From: WILLIFORD Dennis (AREVA) [Dennis.Williford@areva.com]
Sent: Wednesday, May 30, 2012 5:31 PM
To: Tesfaye, Getachew
Cc: BENNETT Kathy (AREVA); DELANO Karen (AREVA); ROMINE Judy (AREVA); RYAN Tom (AREVA)
Subject: Response to U.S. EPR Design Certification Application RAI No. 505 (5902,5735,5869,5754,5803,5950,5744), FSAR Ch. 7, Supplement 22
Attachments: RAI 505 Supplement 22 Response US EPR DC - INTERIM.pdf

The attached file, "RAI 505 Supplement 22 Response US EPR DC - INTERIM.pdf," provides an interim response to one of the remaining two questions (07.01-35). Appended to this file are affected pages of the U.S. EPR Final Safety Analysis Report in redline-strikeout format which support the response to this question. Note that the details of the U. S. EPR FSAR Section 7.6 mark-ups and associated figures will be provided in the final response to Question 07.01-35.

From: WILLIFORD Dennis (RS/NB)
Sent: Tuesday, May 29, 2012 11:23 AM
To: Getachew.Tesfaye@nrc.gov
Cc: BENNETT Kathy (RS/NB); DELANO Karen (RS/NB); ROMINE Judy (RS/NB); RYAN Tom (RS/NB)
Subject: Response to U.S. EPR Design Certification Application RAI No. 505 (5902,5735,5869,5754,5803,5950,5744), FSAR Ch. 7, Supplement

Figure 2.6.13-1—Essential Service Water Pump Building System Functional Arrangement

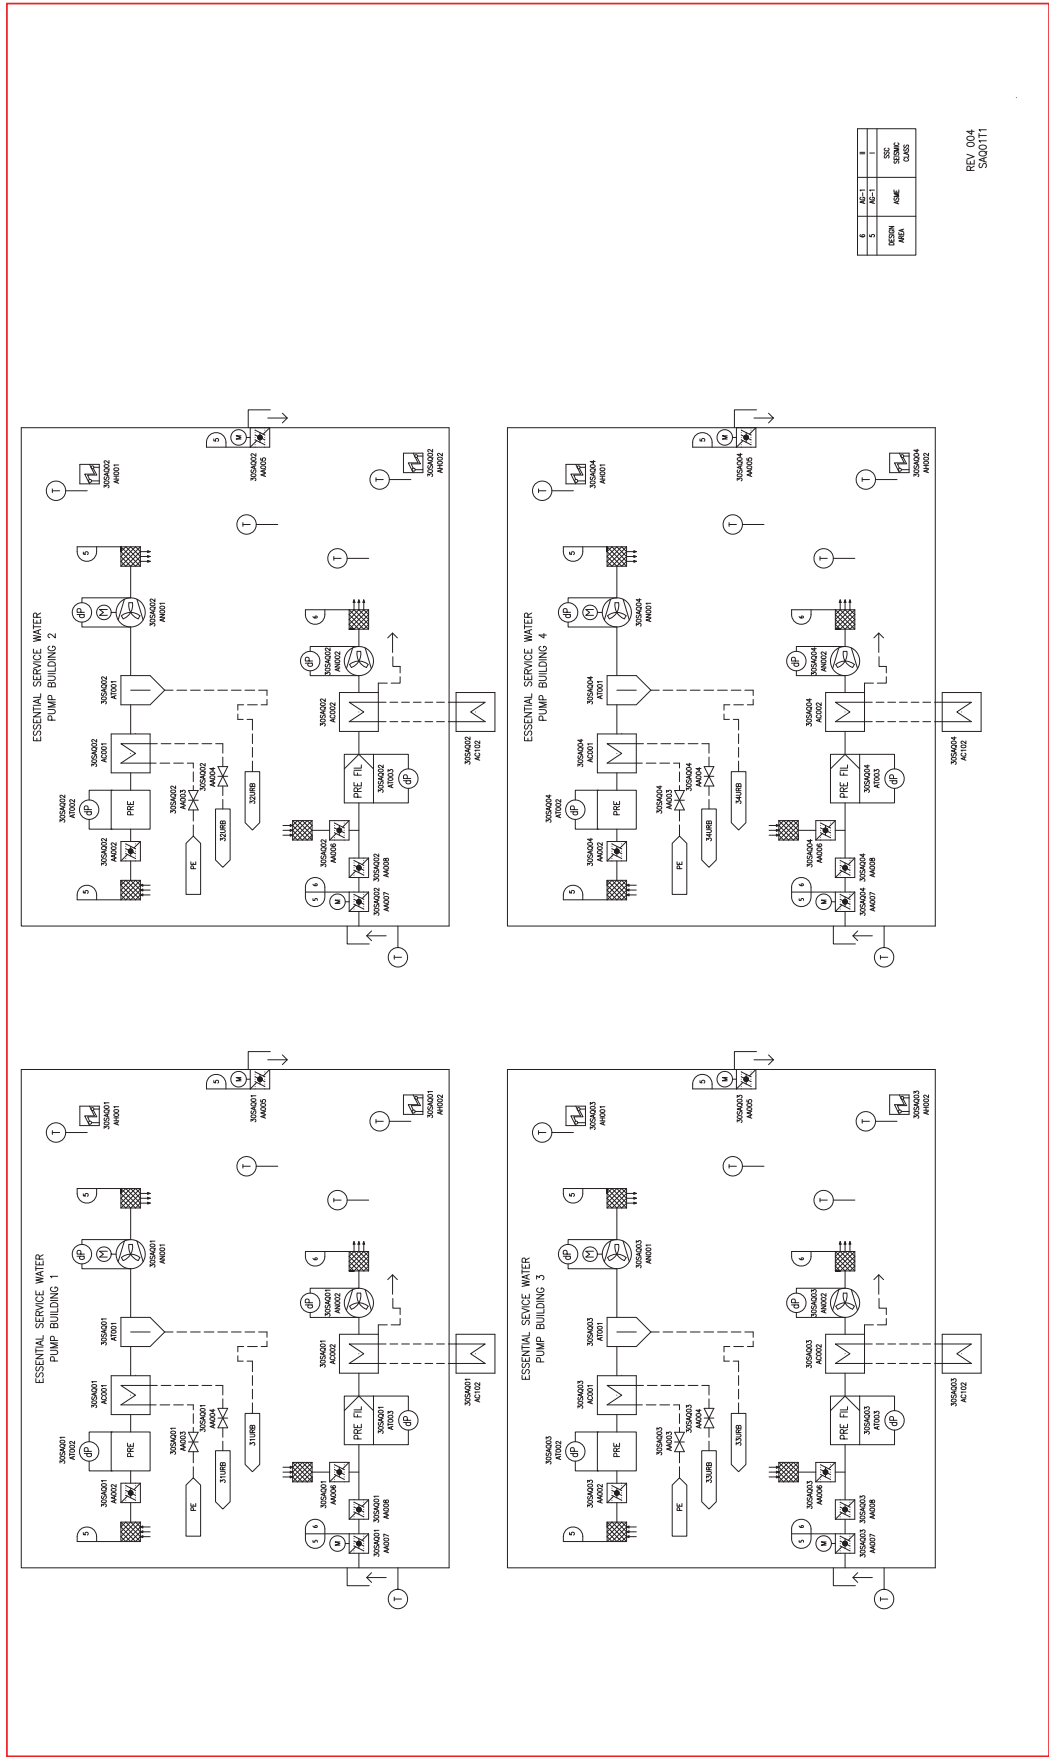
All indicated changes are in response to RAI 505, Question 07.01-35

Figure 7.3-38—ESWPBVS ESWS Pump Rooms Temperature Control

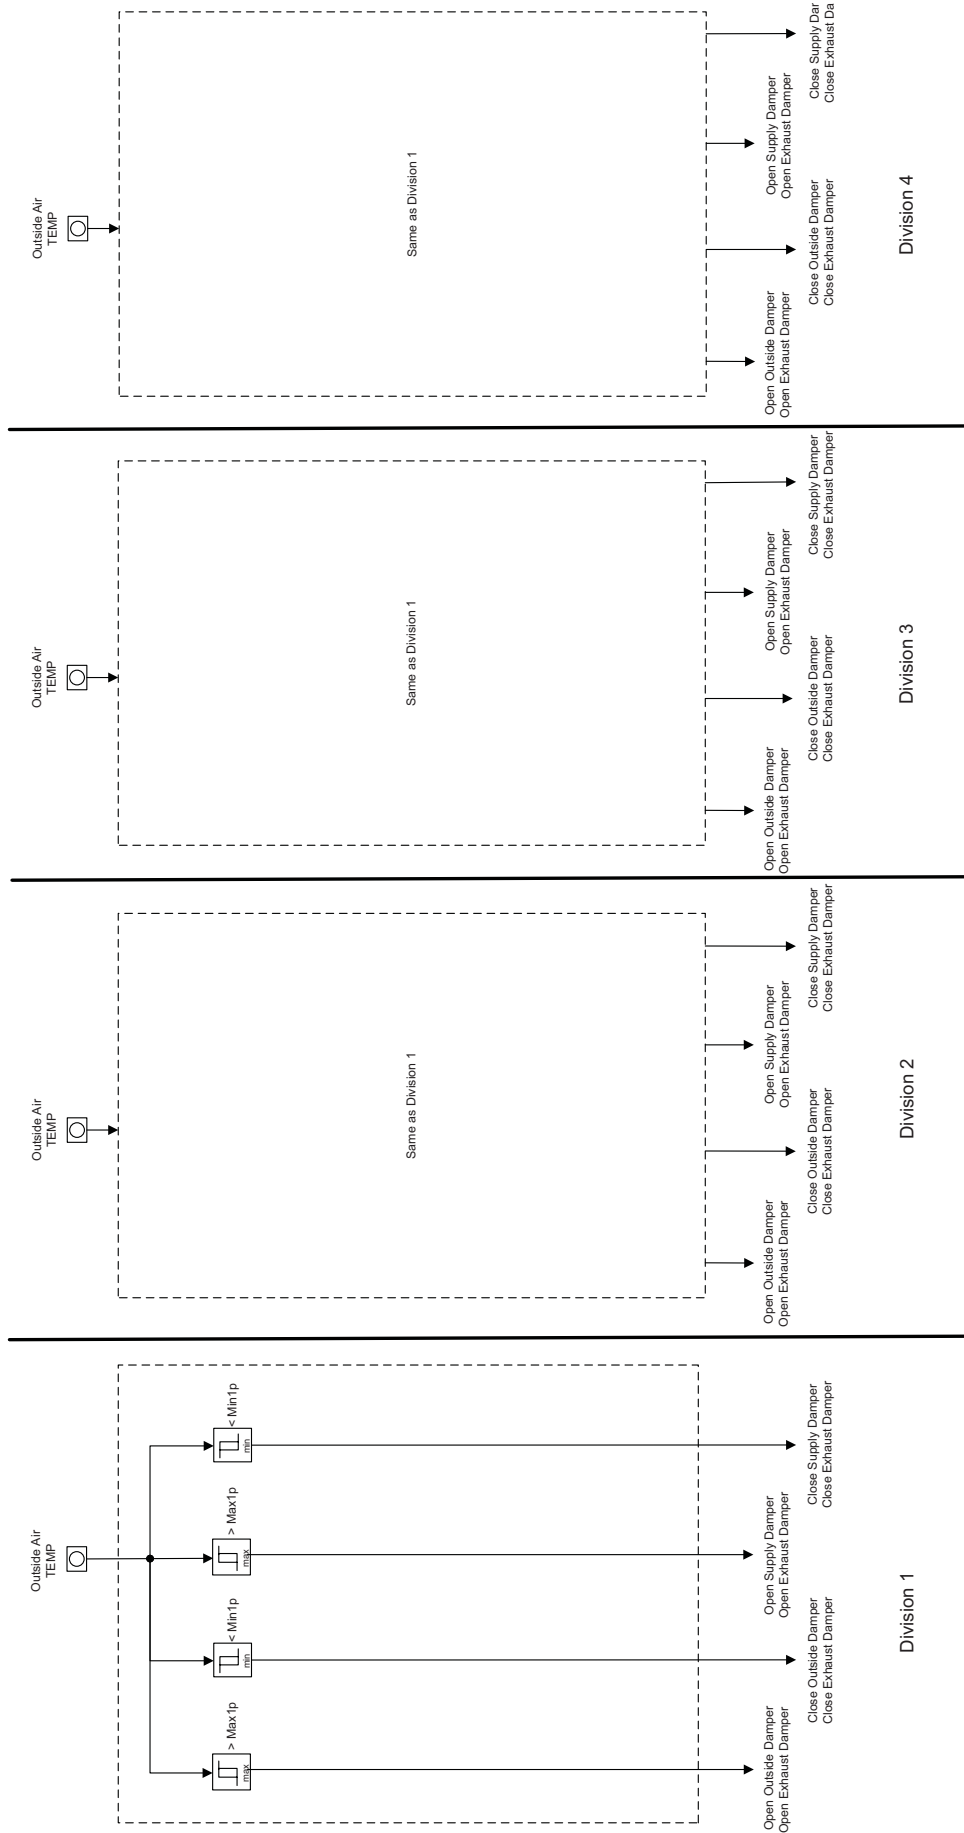
All indicated changes are in response to RAI 505, Question 07.01-35

Figure 7.3-47—SBVS CCWS / EFWS Valve Rooms Heat Removal

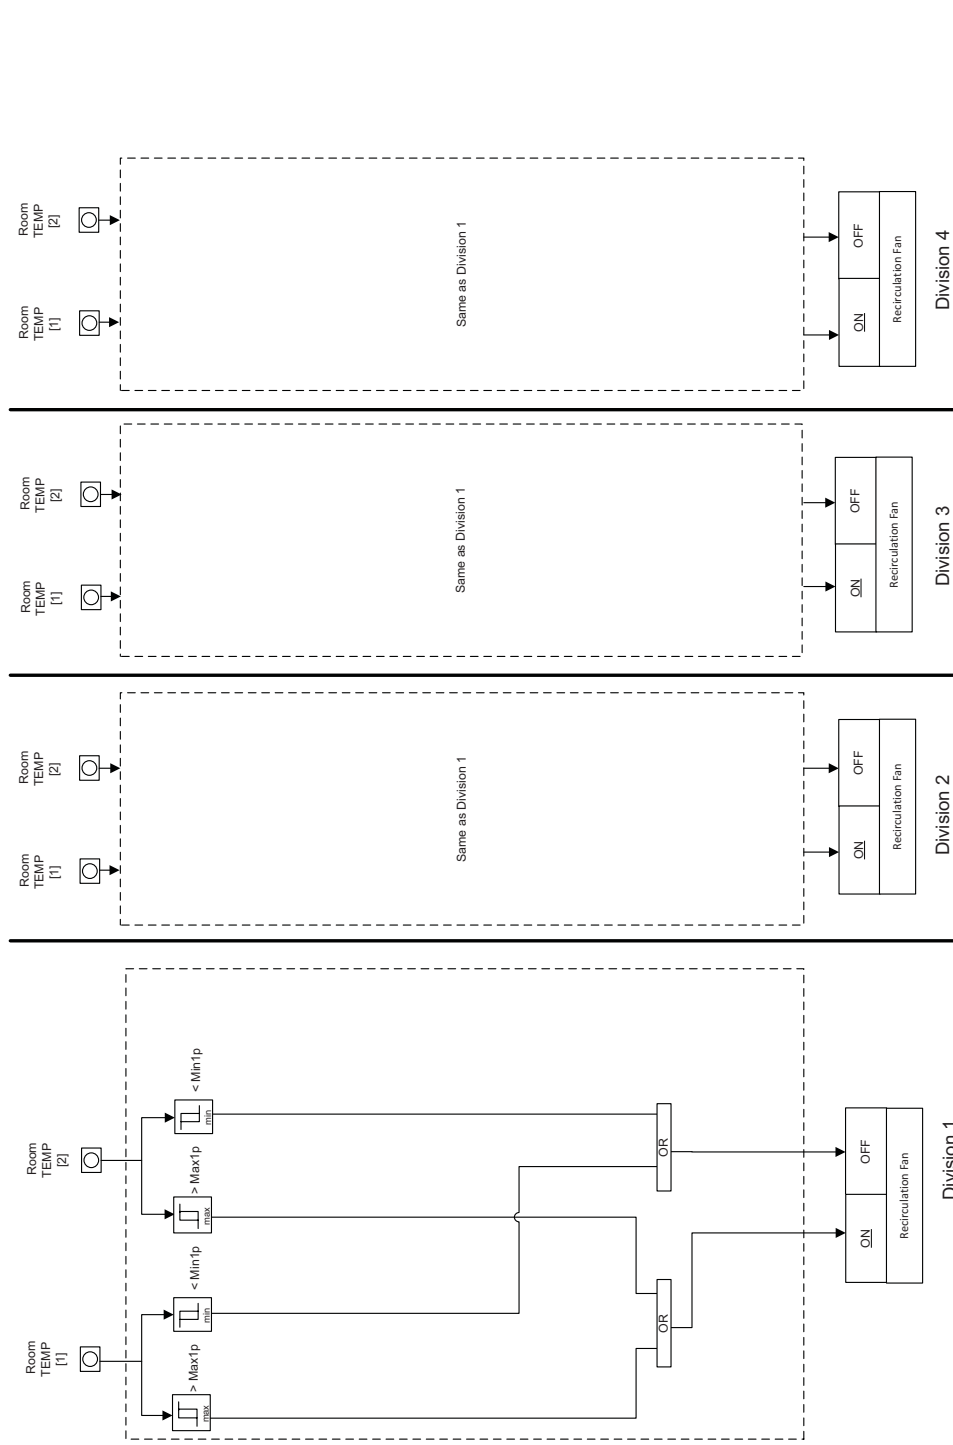
All indicated changes are in response to RAI 505, Question 07.01-35

Figure 7.6-3—Detection of RHR Connected Interlock

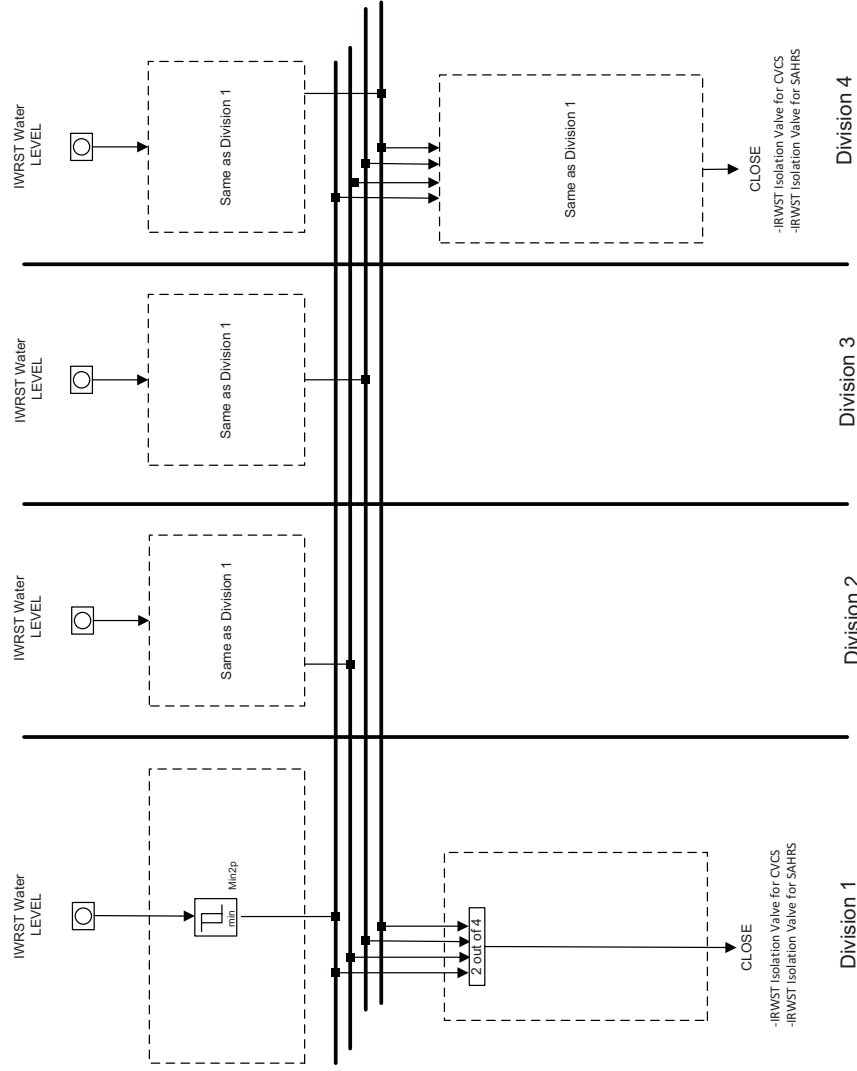
All indicated changes are in response to RAI 505, Question 07.01-35

Figure 7.6-6—SCWS Train 2 to Train 1 Switchover on Train 2 Low Evaporator Flow / Chiller Blackbox Internal Fault / Loss of UHS-CCWS / SCWS Chiller Evaporator Water Flow Control / LOOP Re-Start Failure Interlock

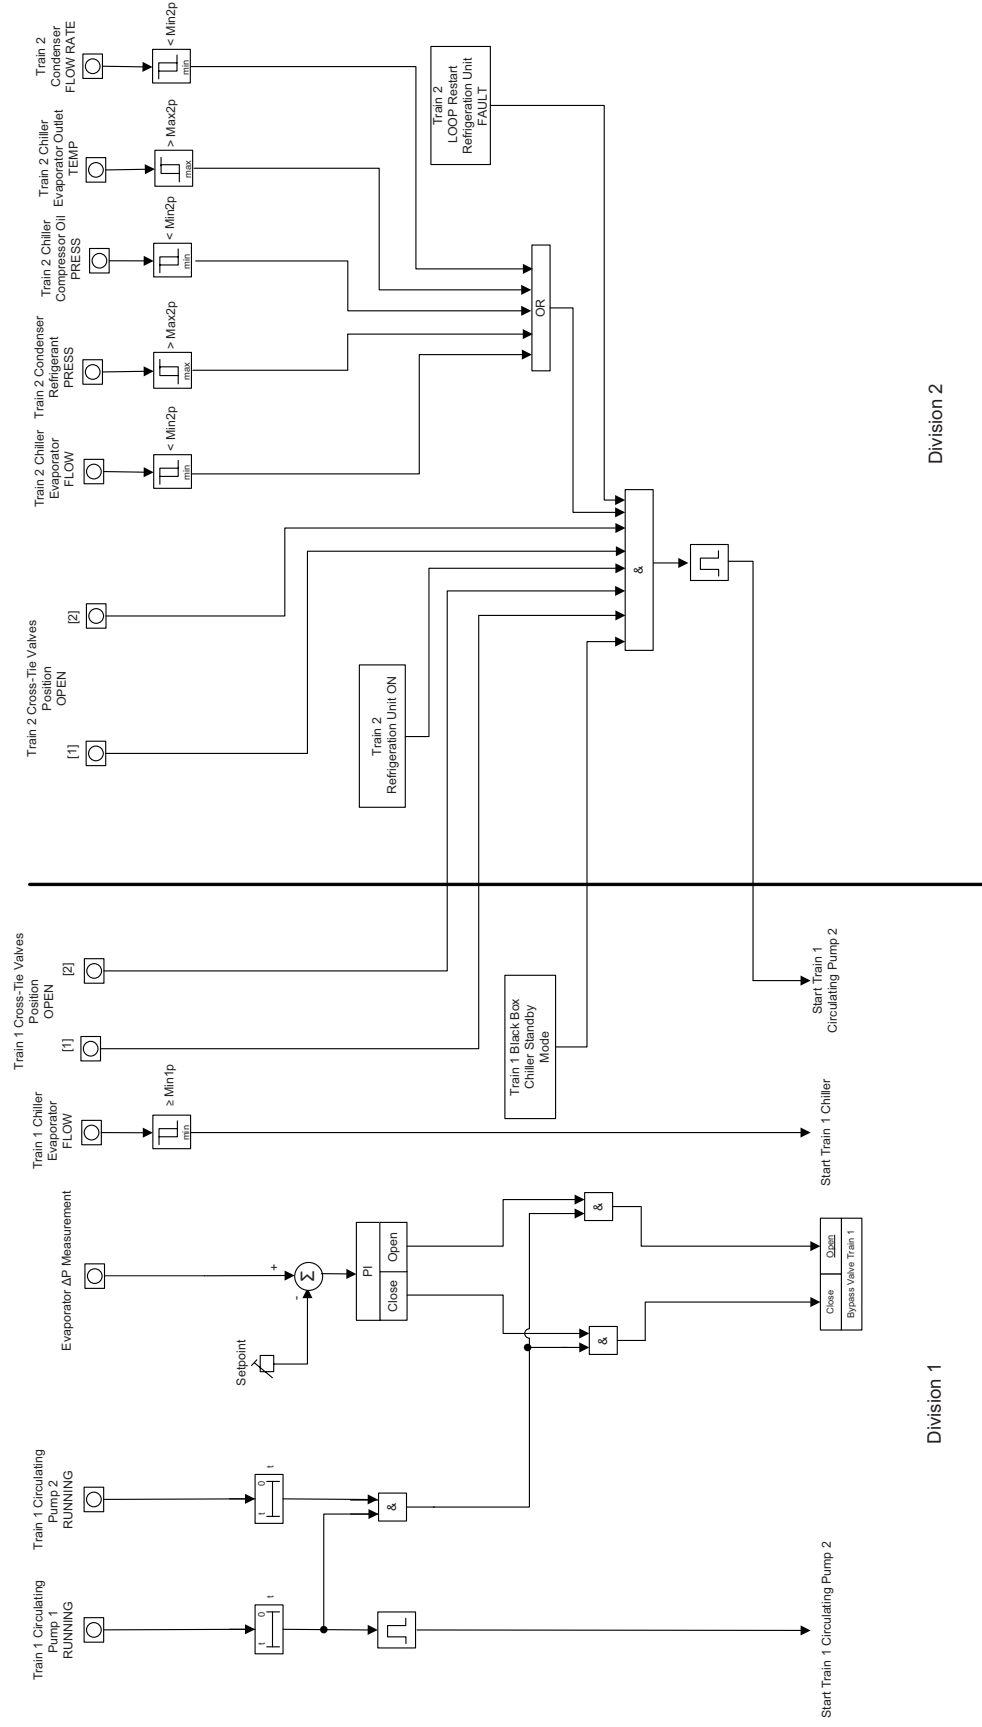
All indicated changes are in response to RAI 505, Question 07.01-35
